73 Congress St. Unit # 5 (2nd Floor, Rear)

Owner: Robert C. Clarke

Plan View & Ceiling Detail

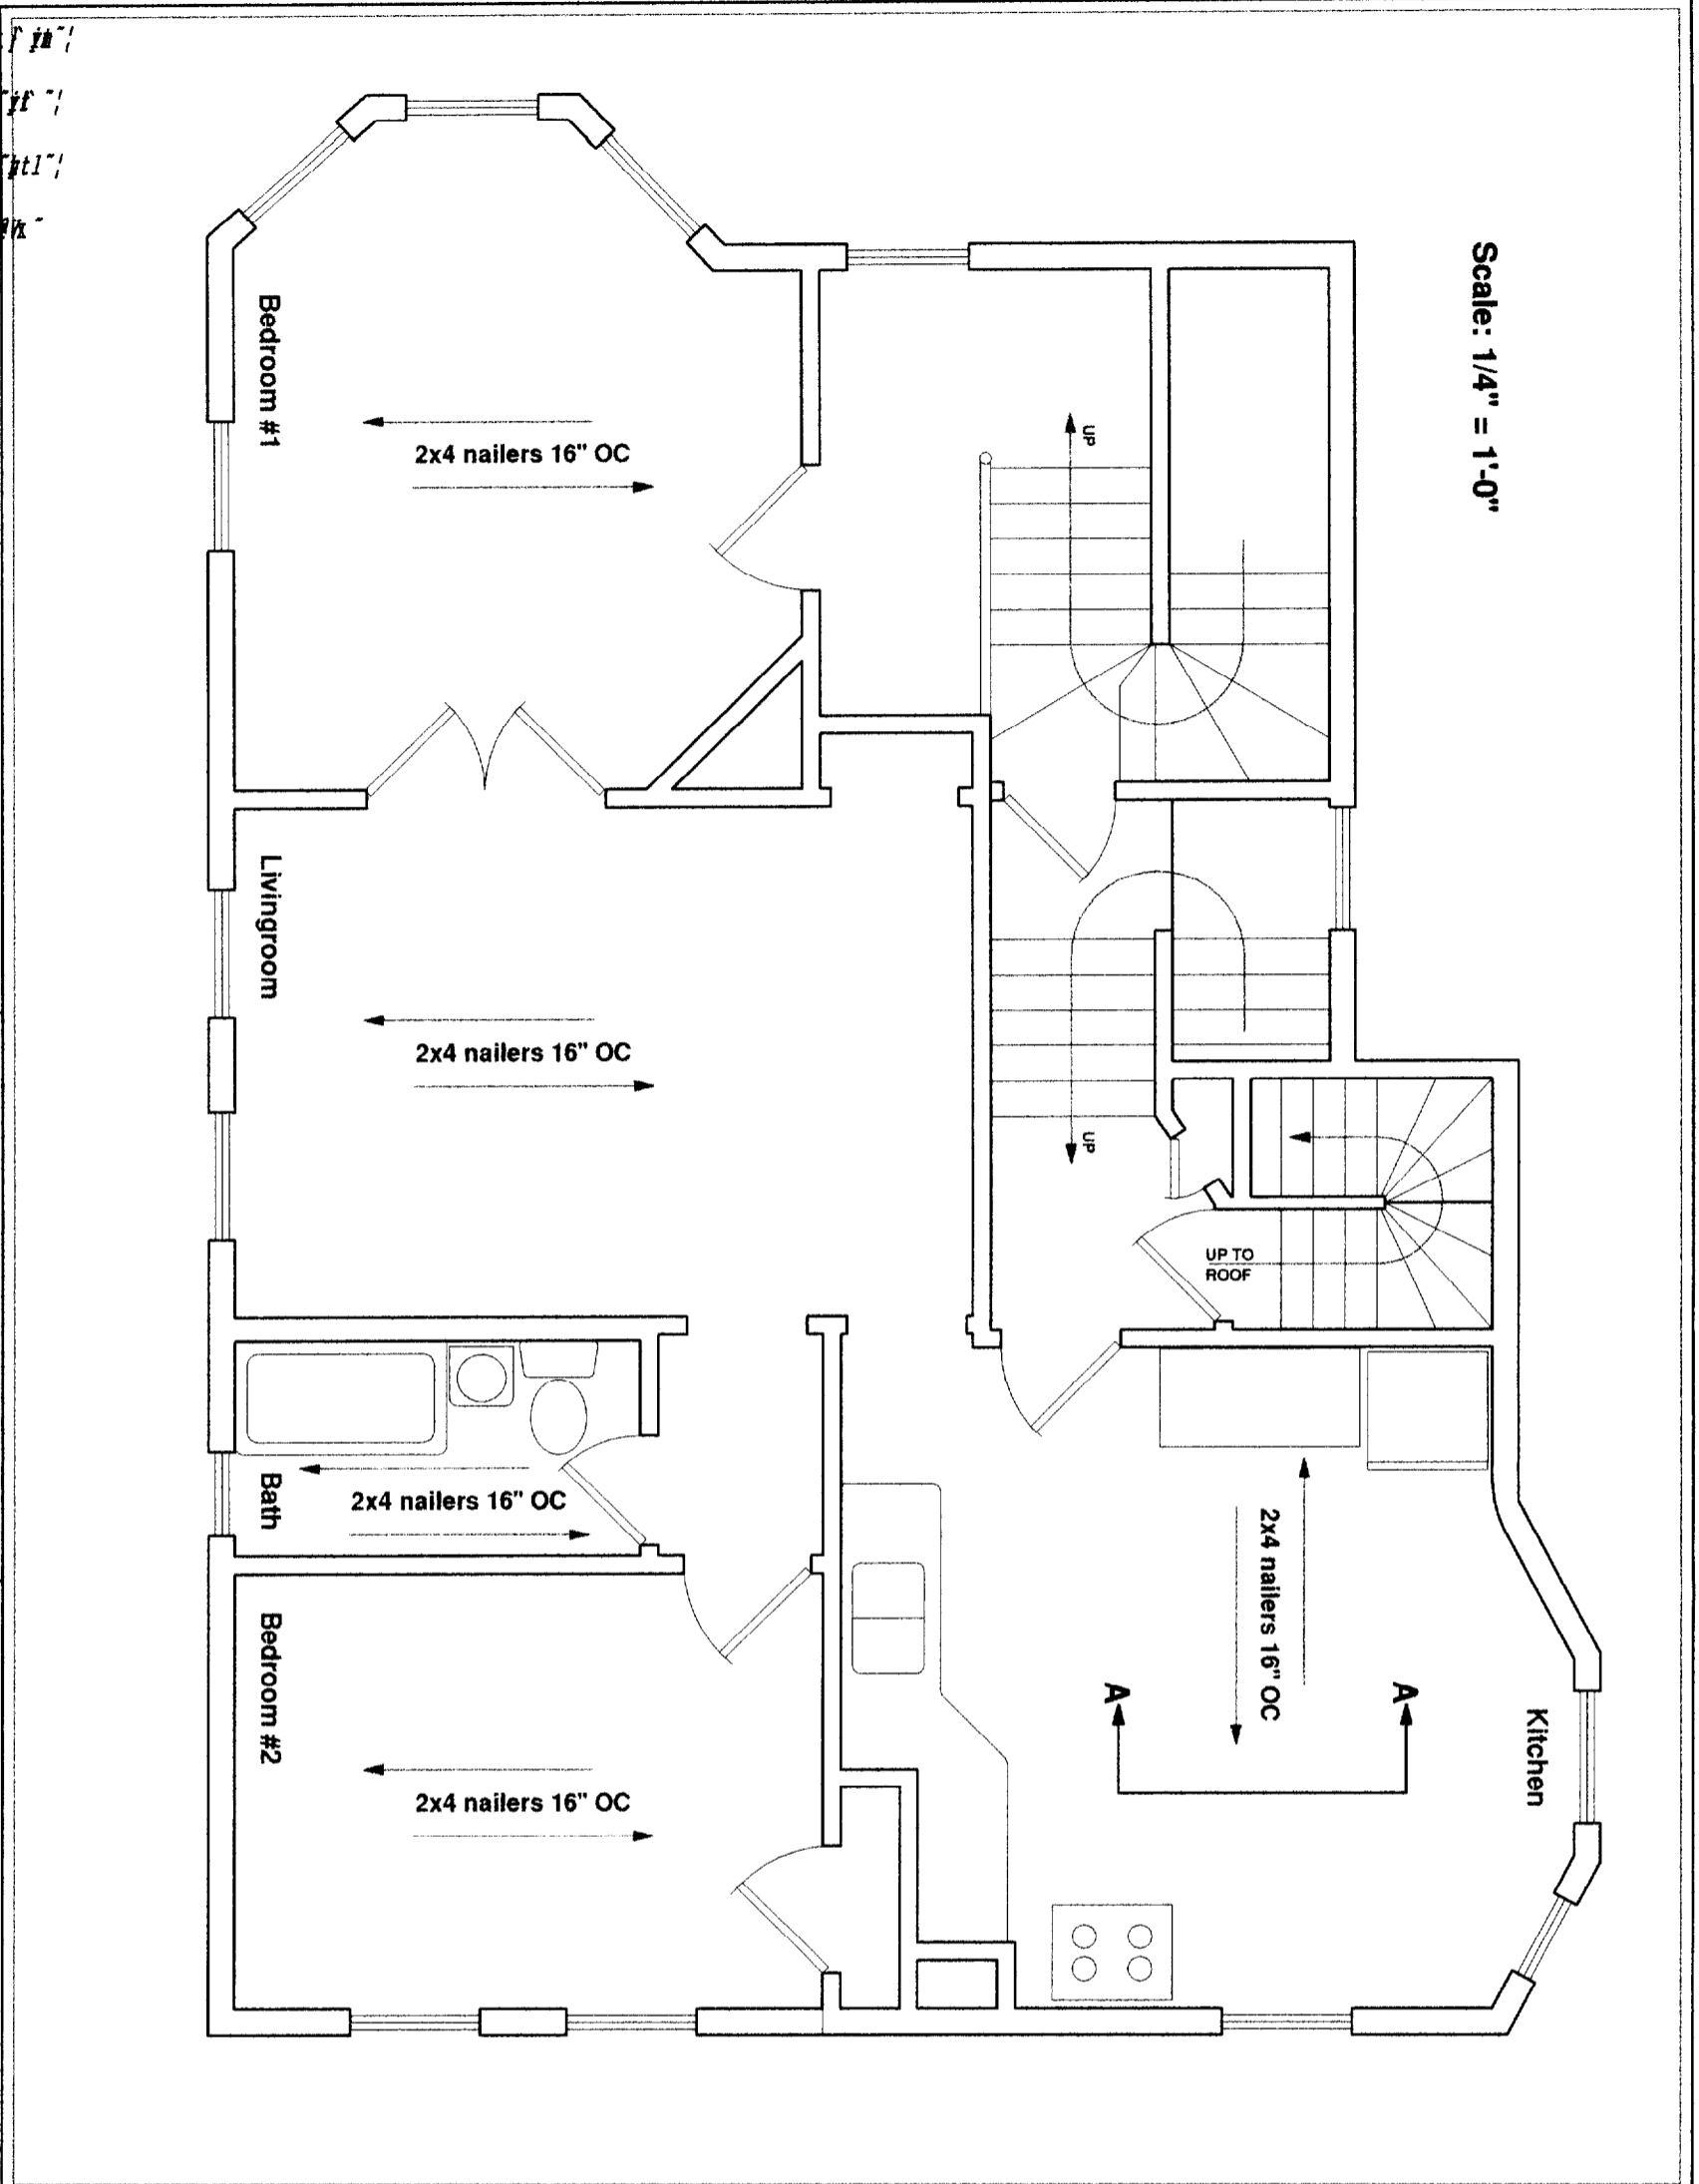
OK - Roof above - only 2 stories on rear - deck not required.
